NZ TRANSPORT AGENCY
WAKA KOTAHİ

Additional Waitemata Harbour Crossing

Internal Road Safety Audit –
Tunnel Option Stage 1 Feasibility

Figure 2.1: Relative rate of speed decrease

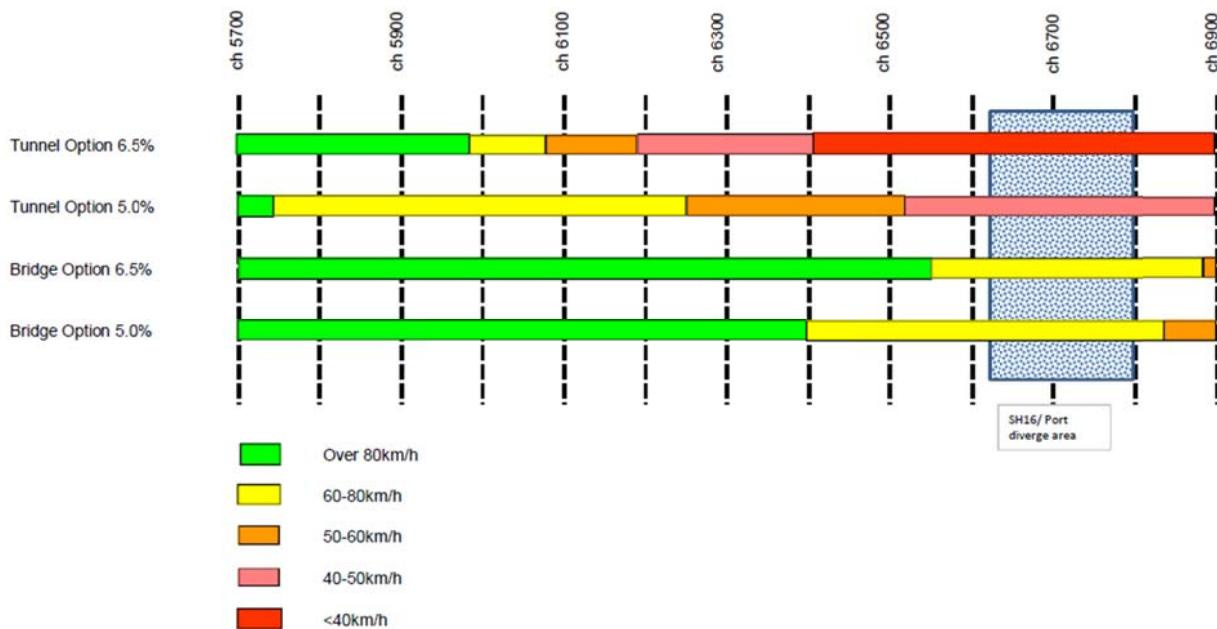
The length of road that a grade is applied will effect the rate that the truck speed will decrease. A comparison of the two tunnel options is provided in Figure 2.1 below, where the location of change in grade has been related to the drop in speed (based on Austroads Guide to Road design Part 3: Geometric Design, Figure 9.3). This diagram also indicates where the diverge area is for the SH16/ Port off-ramp connection.

From this diagram, it can be seen that trucks will begin to reduce speed sooner where the 5% grade is applied, due to the need to extend it over a greater length. However, the rate that speed decreases is less than that for a 6.5% grade, where trucks would be expected to drop below 60km/h before chainage 6100. For both tunnel options, truck speeds would be expected to reduce to below 50km/h through the diverge area, with the 6.5% grade option reducing to less than 40km/h. This is considered to result in significant speed differential, and this is considered a serious concern due to the proximity of the diverge area.

While both the 5% and 6.5% options are considered a serious safety concern, the use of a 5% grade would be preferable due to the slower rate of deceleration, which results in higher speeds through the diverge area.

Figure 2.1: Relative rate of speed decrease

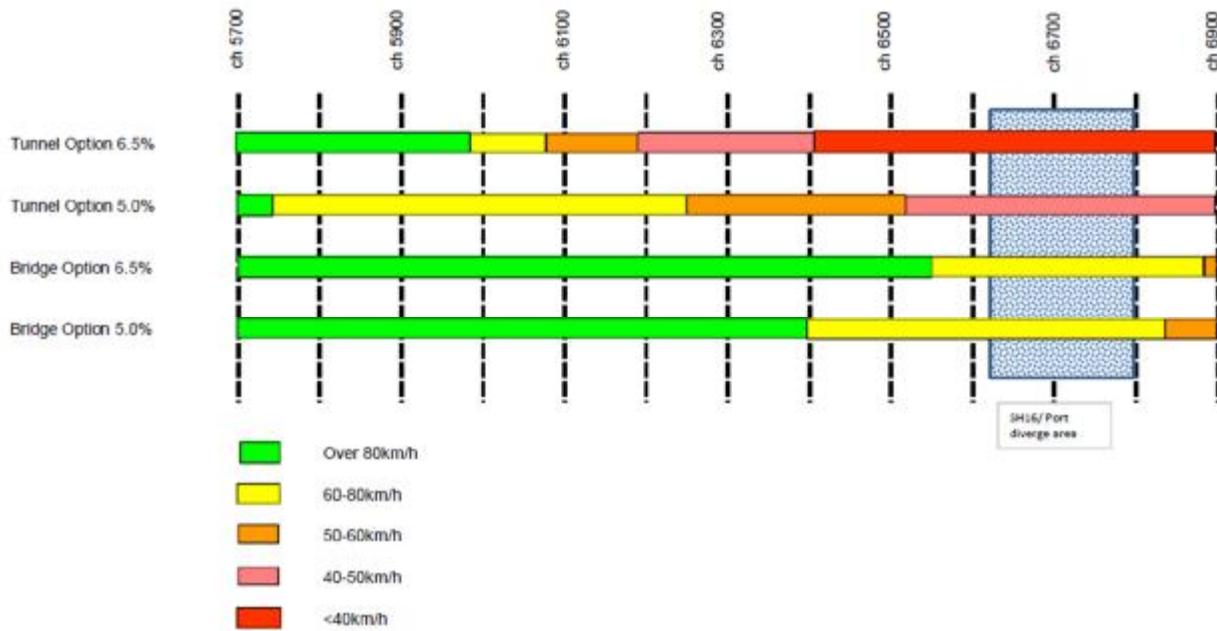
The length of road that a grade is applied will effect the rate that the truck speed will decrease. A comparison of the two bridge options is provided in Figure 2.1 below, where the location of change in grade has been related to the drop in speed (based on Austroads Guide to Road design Part 3: Geometric Design, Figure 9.3). This diagram also indicates where the diverge area is for the SH16/ Port off-ramp connection.

From this diagram, it can be seen that truck speeds will remain above 60km/h through the diverge area for both scenarios, reducing to around 50km/h further south of the diverge area. While this will result in some speed differential between trucks and through traffic, potentially resulting in weave and lane change crashes, truck speeds remain relatively high compared to the driven tunnel.

There is a slight difference in truck speeds for the flatter grade of 5%, as they are able to maintain a higher speed over a longer distance.
